5-F-20-HZ
APPLICATION FOR CERTIFICATE OF APPROPRIATENESS

4 Market Square 37902
Market Square H-1

Staff Report - Certificate of Appropriateness Application

File Number: 5-F-20-HZ

proposed AWNING
material only
change

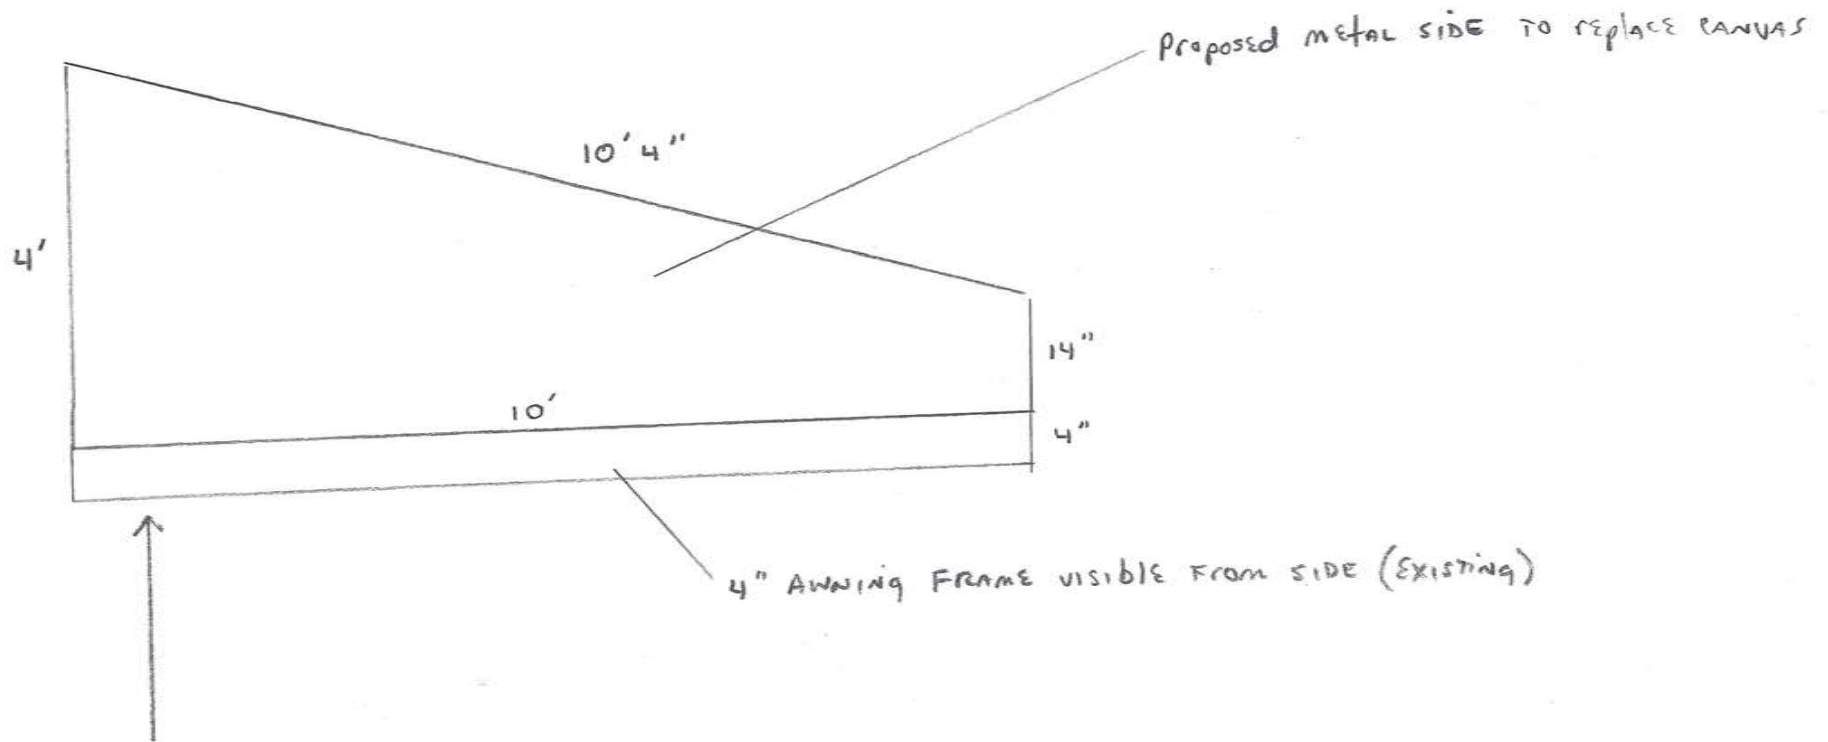
3. The shed shape of the proposed awning, which mirrors the existing, is typical of those in historic photographs in Market Square and of a comparable size and massing to other Market Square awnings. While flat metal canopies have been approved in Market Square, especially on modified storefronts, metal shed awnings have not yet been reviewed by the HZC. Historic photographs of Market Square indicate that sloped awnings were generally canvas. There is not sufficient historic precedent for standing-seam metal awnings in Market Square.

5. Standing-seam metal is a material commonly used for roofs. On an awning of this scale and massing, the installation of standing-seam metal would make the awning resemble a roof structure which is permanently fixed to the building.

Staff recommends approval of replacement of the existing canvas awning, but denial of the proposed standing-seam metal material due to a lack of historic precedent. Staff could approve a replacement canvas material on the existing frame. Staff recommends approval of the associated wood fascia repairs on storefront systems.
